Tunbridge Wells Borough Local Plan Examination

Hearing Statement prepared on behalf of Hadlow Estate

Matter 7 – Highways Infrastructure

Issue 1 – Strategic and Local Road Networks

Figure 20: Hotspot Junction Locations – Local Plan Highway Mitigation Option 1

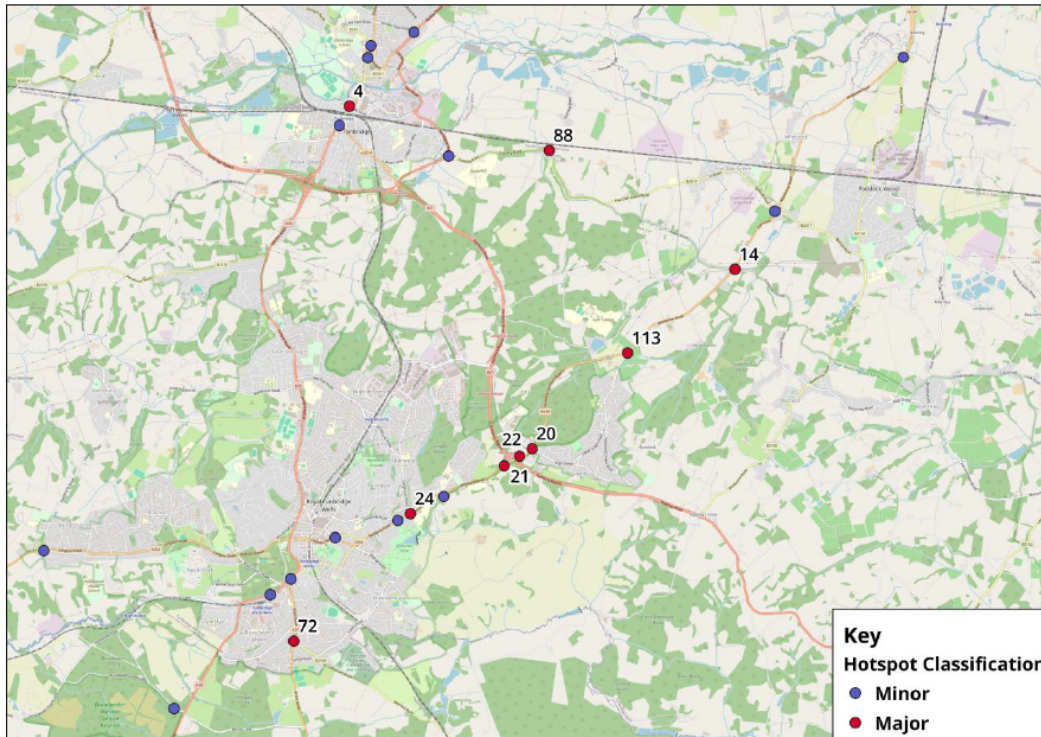
Junction 4 (B2260 High Street / Railway Approach / Vale Road / Barden Road) is now identified as a hotspot in this scenario but there is no reference to these new hotspots in the text of Appendix 1. It is unclear how far these new scenarios have been interrogated as part of the evidence base.

Moreover, although it was indicated at the Matter 3 hearing that hotspots in Tonbridge town centre no longer arose with the removal of Tudeley, in the above scenario this does not appear to be the case.

With Tudeley in place, the impacts within Tonbridge would not be severe (as explained in Markides Associates' response to the Inspector's Initial Findings⁷ and the Council's hearing statement⁸). However, no further analysis of the impacts on Tonbridge town centre has been carried out as part of the updated evidence base, despite the information shown above in Figure 20.
